Sequoyah Nuclear Plant, Unit 1 and 2
Facility Operating License Nos. DPR-77 and DPR-79
NRC Docket Nos. 50-327 and 50-328

Subject: **Response to NRC Request for Additional Information Regarding Overall Integrated Plan for Reliable Spent Fuel Pool Instrumentation (Order No. EA-12-051) (TAC Nos. MF0794 and MF0795)**

**TENNESSEE VALLEY AUTHORITY
SEQUOYAH NUCLEAR PLANT, UNITS 1 AND 2**

**RESPONSE TO NRC REQUEST FOR ADDITIONAL INFORMATION
REGARDING OVERALL INTEGRATED PLAN IN RESPONSE TO THE COMMISSION
ORDER MODIFYING LICENSES WITH REGARD TO REQUIREMENTS FOR
RELIABLE SPENT FUEL POOL INSTRUMENTATION**

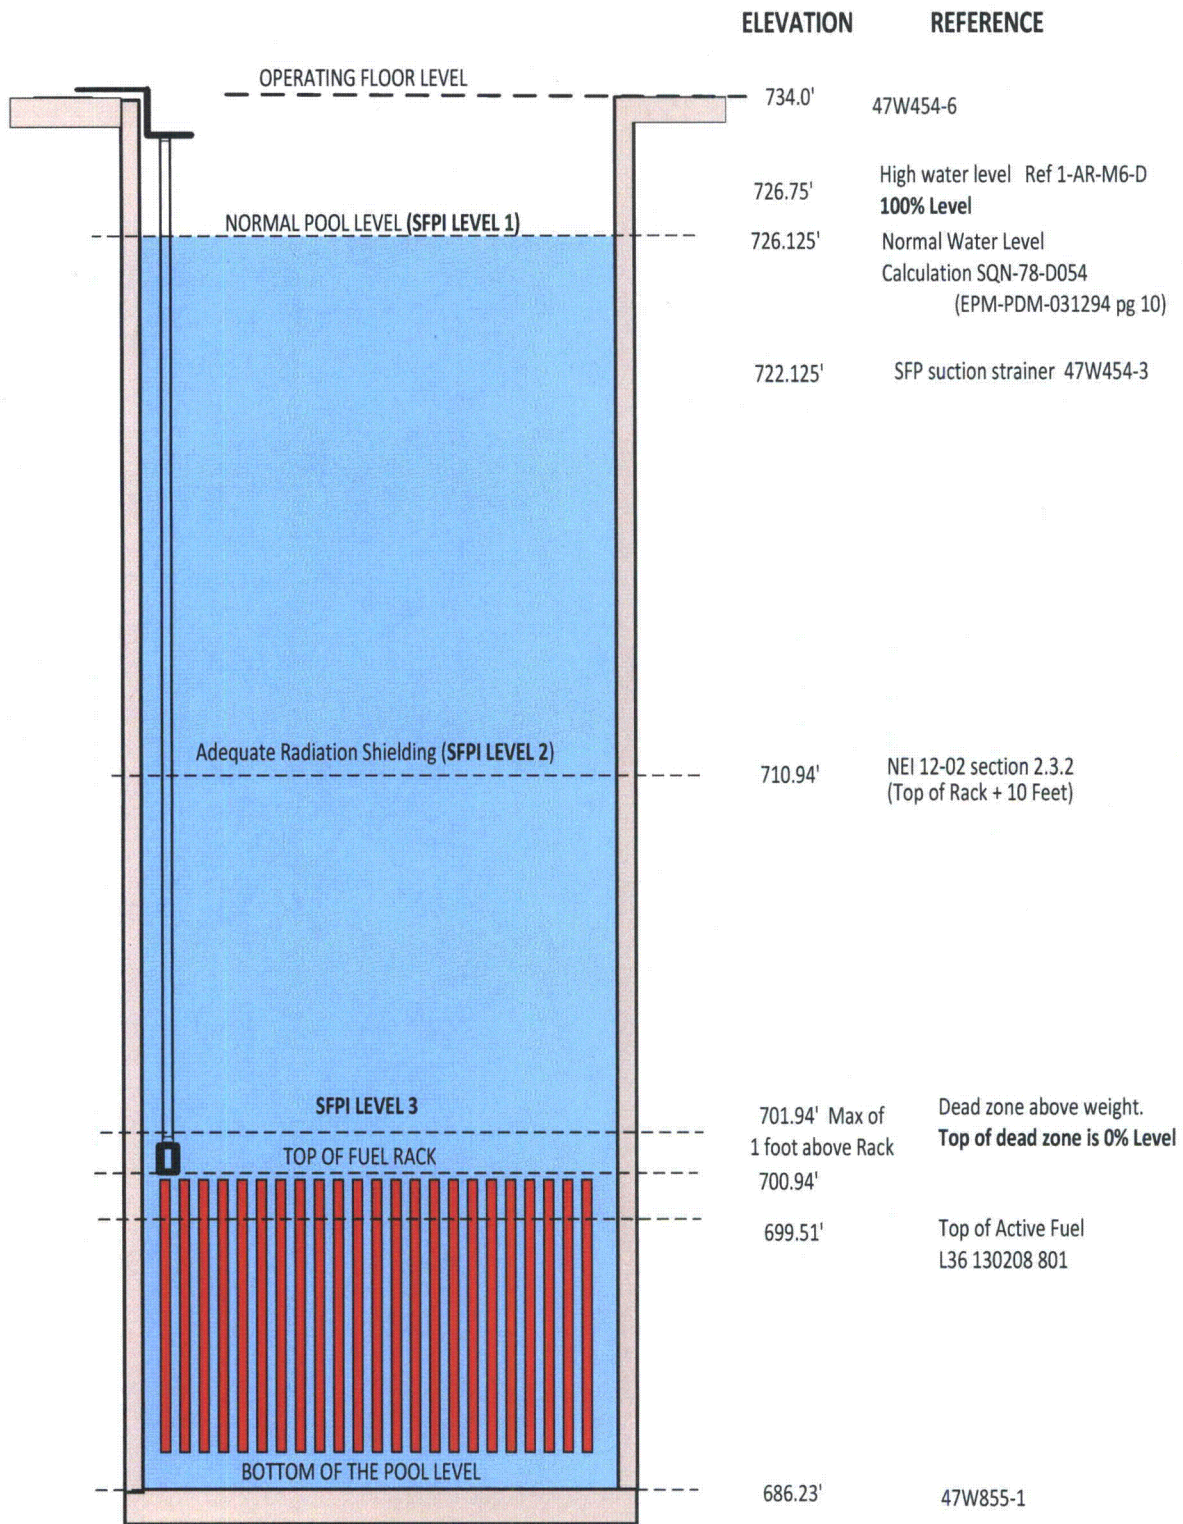
- a) *The specific elevations within the plant SPF [sic] corresponding to the three levels described in the guidance provided in NEI 12-02 Revision 1. For Level 1, specify how the identified elevation represents the HIGHER of the two points described in the NEI 12-02 guidance for this level.*

- b) *A clearly labeled sketch depicting the elevation view of the proposed typical mounting arrangement for the portions of the instrument channel consisting of permanent measurement channel equipment (e.g., fixed level sensors and/or stilling wells, and mounting brackets). Indicate on this sketch the datum values representing Level 1, Level 2, and Level 3, as well as the top of the fuel. Indicate on this sketch the portion of the level sensor measurement range that is sensitive to measurement of the fuel pool level, with respect to the Level 1, Level 2, and Level 3 datum points.*

- c) *Clarification regarding your statement "TVA defines top of fuel storage rack to be the level within one foot above the rack." Elsewhere in your submittal it is stated:*

"Level where fuel remains covered - Indicated level on either the primary or backup instrument channel of greater than 0 feet above top of fuel storage rack."

Please provide an accurate description of the how the instrument level measurement range will envelope the three required Levels to be monitored per the Order requirements and the guidance in NEI 12-02, including how the bottom of the level measurement range relates to the top of the fuel racks.

- a) *The specific elevations corresponding to the three levels are indicated on the sketch on page E4. TVA will use the normal spent fuel pool level at SQN (726.125 feet) as Level 1. This complies with NEI 12-02 requirements as outlined below:*
 - *Level at which reliable suction loss occurs due to uncovering of the coolant inlet pipe.*

The SQN suction strainers are at elevation 722.125 feet.

- *The level at which the water height, assuming saturated conditions above the centerline of the cooling pump suction provides the required net positive suction head (NPSH) specified by the pump manufacturer or engineering analysis.*

The SQN Spent Fuel Pool Cooling System Hydraulic Analysis has determined that adequate NPSH for SFP cooling pumps exists for temperatures up to 192 degrees Fahrenheit (F). In addition, SQN procedure 0-SO-78-1, "Spent Fuel Pit Cooling System," contains instructions to throttle SFP cooling flow above 192 degrees F to ensure adequate NPSH.

- b) Sketch for Spent Fuel Pool Instrumentation (SFPI) Level is included on the following page.
- c) The Guided Wave Radar system can only sense level changes above the weight and there is a small distance above the weight that the manufacturer defines as the dead zone. Preliminary discussions with the manufacturer have indicated that the total distance above the SFP rack where level changes cannot be detected is less than one foot. The exact distance has not been specified at this point. Refer to sketch for Spent Fuel Pool Level shown below. The space shown below Level 3 and above "Top of Fuel Rack" is the area where level changes would not be detected. TVA will utilize the top of the dead zone as Level 3 instead of Top of Fuel Storage Rack.

Route from Main Control Room to Electric Board Room

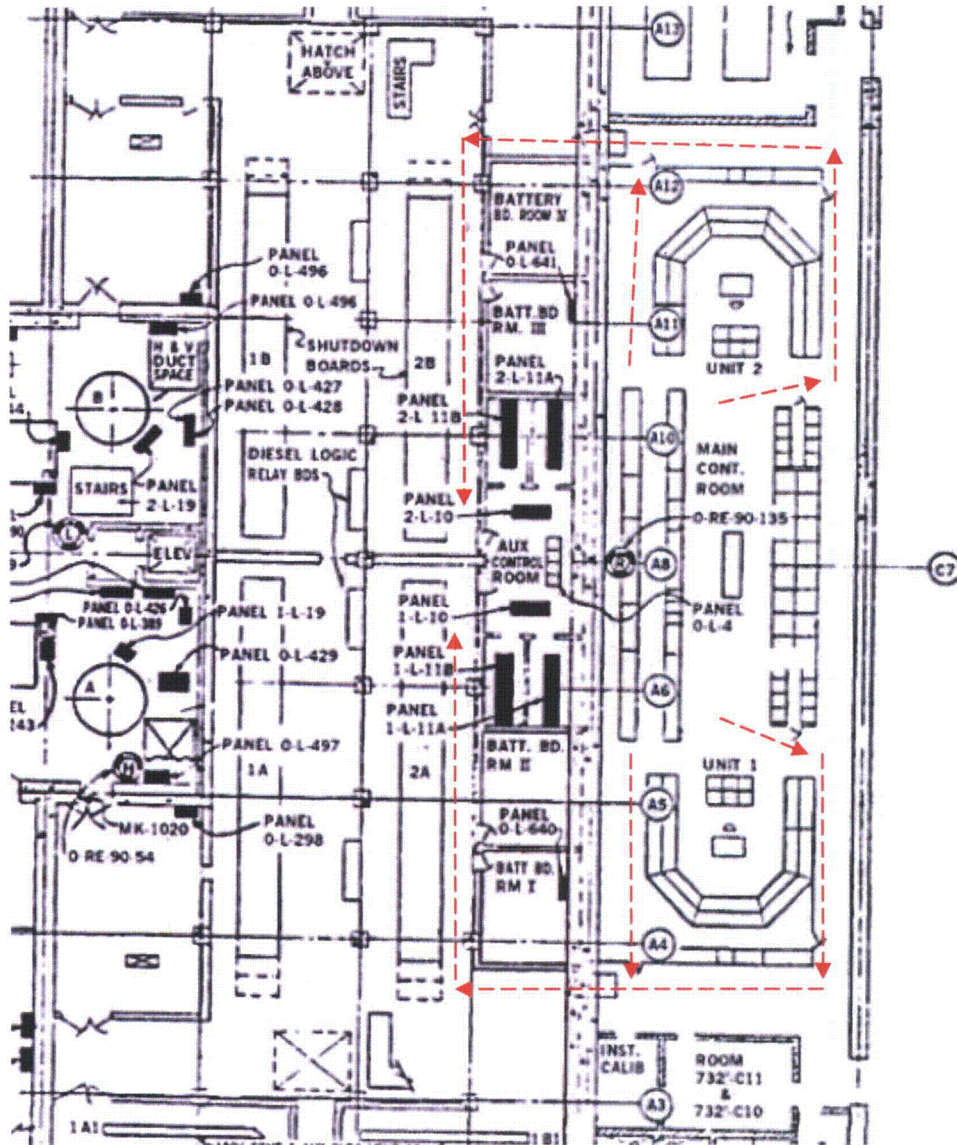
- a) *A description of the specific location for the back-up display that is not located in the Main Control Room.*
- b) *For display locations that are not within the main control room, provide a description of the display location that addresses primary and alternate access route evaluation, continuous habitability at display location(s), continual resource availability for personnel responsible to promptly read displays, and provisions for verbal communications with decision makers for the various SPF drain-down scenarios and external events.*
- c) *The reasons justifying why the locations selected enable the information from these instruments to be considered "promptly accessible" from a response time perspective. Discuss various drain-down scenarios.*

- a) One instrument channel display for each unit is anticipated to be located in the Electric Board Room, which is in close proximity to the Auxiliary Control Room. More detail is provided in response b) below.

- b) One instrument channel display for each unit will be located in the Main Control Room. Engineering for the SFPI Level channels is in progress; however, the exact location for the battery pack/display enclosure for both channels has not yet been determined. The second instrument channel display for each unit is anticipated to be located in the Electric Board Room, which is in close proximity to the Auxiliary Control Room. The Electric Board Room is a mild environment, is promptly accessible (2 minute walk) by main control room personnel and is not subject to the environmental conditions associated with boiling in the SFP. Communications by radio or telephone is available if needed. The route to the Electric Board Room/Auxiliary Control Room area from the Main Control Room will be the same route that is utilized during design basis events because the route is within a safety related, seismic structure. The pathway is expected to remain intact following a seismic event. See the sketch below for the route from the Main Control Room to the Electric Board Room.

- c) The Electric Board Room is in a mild environment and is promptly accessible (2 minute walk) by main control room personnel. Therefore, the environment is not affected by the environmental conditions associated with any drain down scenario.
